PLANNING AND ZONING COMMISSION
NOTICE OF REGULAR PUBLIC MEETING

Item # 7

RE: Public Hearing and Recommendation to City Council regarding the Replat of 5.18 acres of Lot 17 Siena Creek Phase One to form 18 R-1 Single Family Townhouse Residential Lots, two common area lots and the ROW for Maravilla Way, a private street; and the replat of all of Lot 18 Siena Creek Phase Two to form 7 R-1 Single Family Townhouse Residential lots and a 50 foot ROW for Arollo Court, a private street; Ron Mitchell is the Applicant

Siena Creek Phase One (Replat Request): A Portion of Lot 17 and Lot 18

SHEET: 3 OF 4

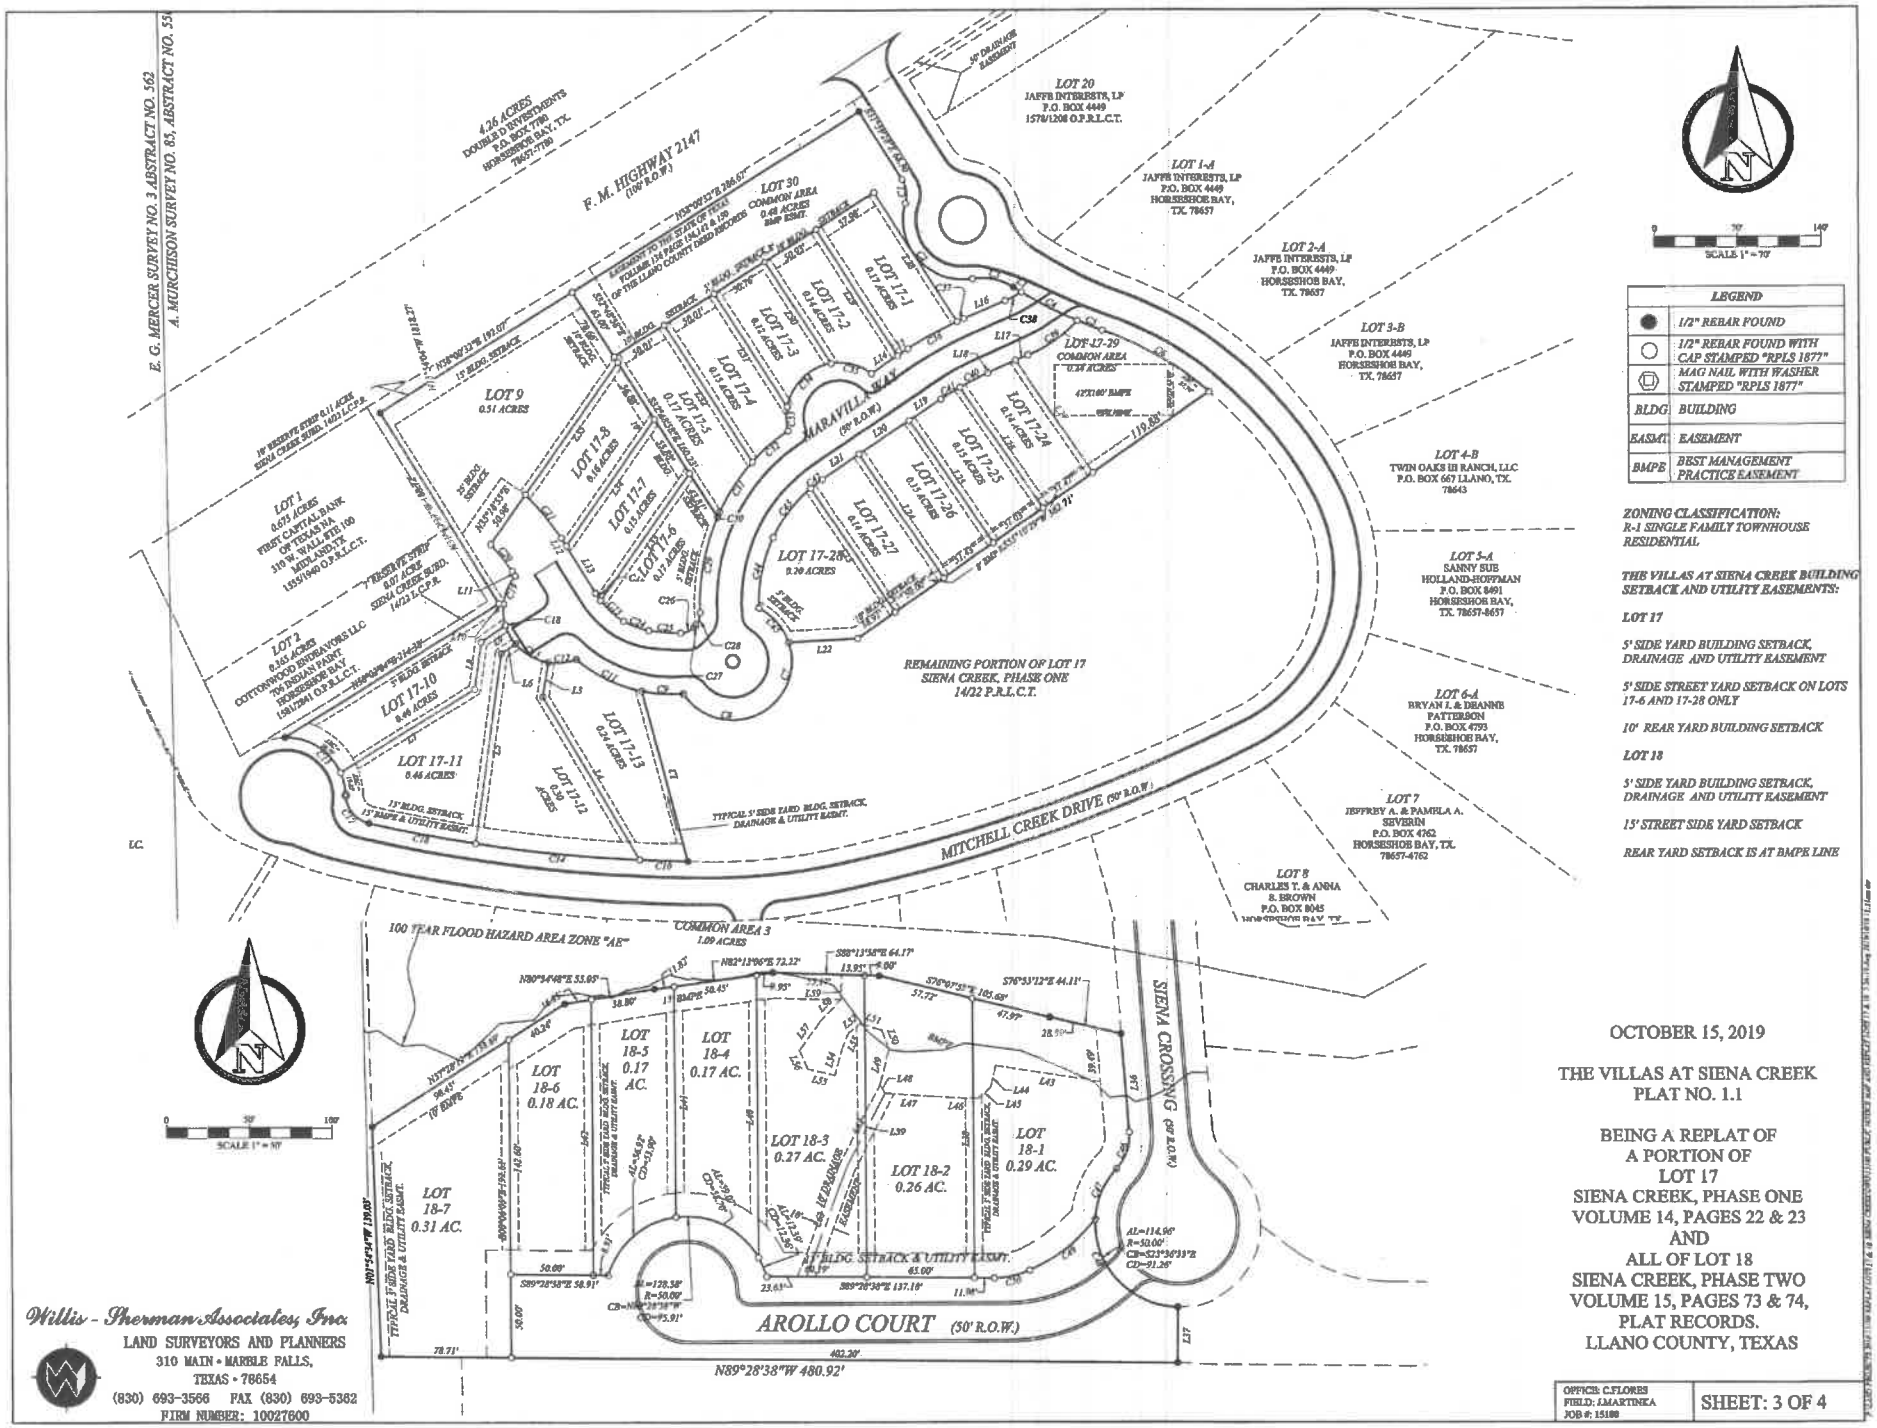
1. **In the dedication change the word "do" to 'does hereby adopt";**
2. **In the dedication add an "s" to dedicate "and hereby dedicates";**
3. **On the dedication signature lines revise the spelling of Ron Lynn Mitchell's middle name to have 2 n's;**
4. **Change date in the signature area for the Development Services Director signature to 2019;**
5. **Change the name of the mayor in the signature line to reflect our new mayor;**
6. **The LCRA Development Permit Plat Note and the Development Permit Plat Note are the same note. Please remove one of the notes.**

7. **Remove the extra text outside of and to the left of the Legend;**
8. **Show property line between the two properties to the west of Lot 18;**
9. **Better delineate the 100-year flood plain along the back of Lot 18 so it is easier to see on the plat;**

10. **Label the BMP area and 100-year flood plain as a D.E.;**
11. **Provide Finished Floor Elevations for lots along Arollo Court;**
12. **Remove the words "Lake LBJ Municipal Utility District" and "Horseshoe Bay Water Control and Improvement District No. 2" from the right side of the plat drawing (along Pecan Creek). This is not necessary. Both are City of Horseshoe Bay.**

13. **On pages 2 of 4, and 3 of 4, show on the plat drawing and note on the right hand side of the page, Front Yard Setback 15 feet for the individual lots within both original Lot 17 and Lot 18.**
